RE: Dawson Gold Mine, Permit No. M-2021-046

On behalf of Mr. David Felderhof, please accept the following response to the Division's October 14, 2021 Preliminary Adequacy Review.

Figure 1: Schematic of Underground Workings.

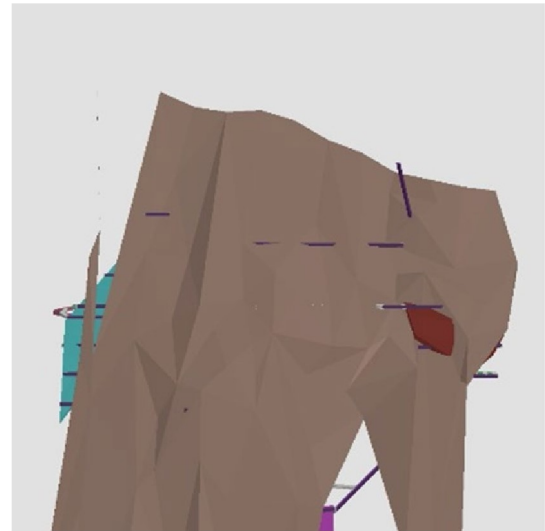
1. The underground workings will be developed in rock similar to the development rock samples tested as part of the tailings characterization program. A schematic of the underground is shown below Figure 1. The unmodeled space is composed of granites. The brown feature in the hanging wall is the sulfide zone.

As can be seen in Figure 1, the majority of the workings are in the granitic host rock and do not expose the sulfide zone. The granitic rock, as described in the tailings characterization report, is non-potentially acid generating and metal content similar to the typical crustal abundance of granite.

Figure 2: Schematic of Sulfide Zone

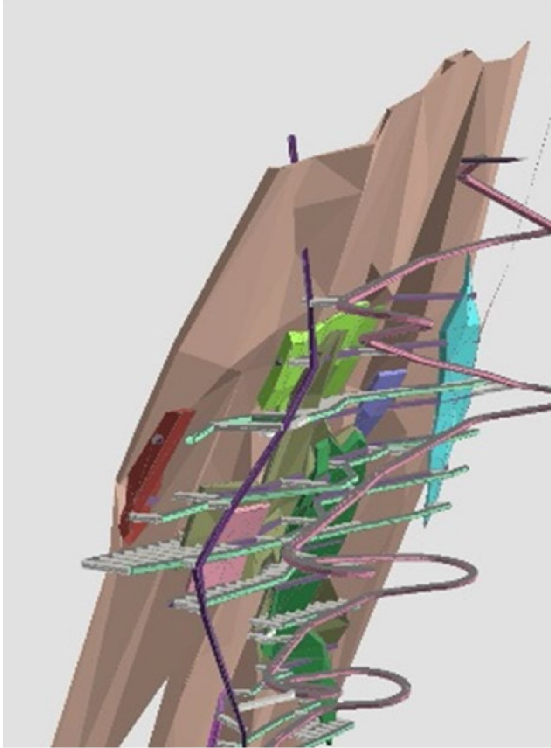
The underground workings do pierce the sulfide zone in selected areas. These are shown in Figure 2. The area of exposed surface area in the sulfide zone is small relative to the exposed surface area within the granite. It is reasonable to expect the exposed sulfide zone to produce acidity locally, however, the lag period to do so is unknown at this time. The granitic host rock does provide carbonate neutralization that would neutralize acid production.

At closure, the mine will be allowed to flood, at which time anoxic conditions will be re-established and oxidation will essentially cease. For a period of time after flooding, secondary oxidation products will solubilize and diffuse into the groundwater until the inventory of secondary oxidation products is consumed. In the long term, it is expected groundwater quality within the mine workings will return to background levels.
